Date 1.2013 Group **371** No. **044** Release **01** Page 1(3)

Battery Cable Mounting Clamp
VN, VHD, VT, VAH

FSB 371-044, Battery Cable Mounting Clamps

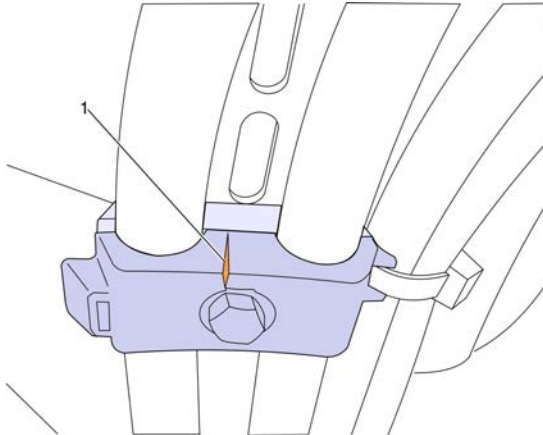
- 1 Secure the vehicle for service by parking it on a flat level surface, applying the parking brake, chocking the rear wheel, and placing the transmission in neutral.
- 2 Inspect battery cable clamps, from battery to starter, to determine how many clamps are cracked or broken.

Note: If no broken clamps are found no further repairs are needed.

W2079310

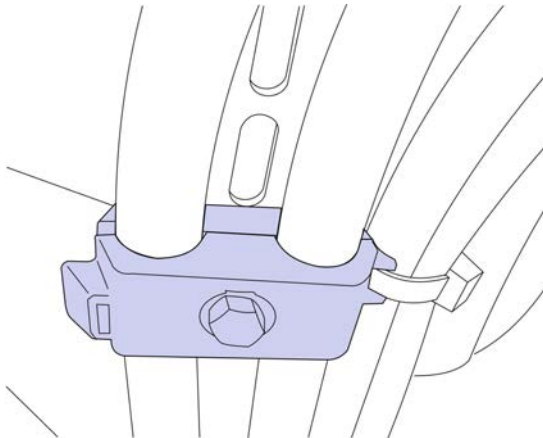
1. Broken or cracked clamp
- 3 Remove the clamp from the bracket mount and cables.
- 4 Install new clamp part # 21658909 onto the cable and secure bracket mounting. Replace cable ties as required.

Torque the nut to: 8.1 ± 1.4 Nm (6 ± 1 ft-lb)

Note: Ensure new clamp is positioned correctly before snapping together otherwise repositioning may be difficult.
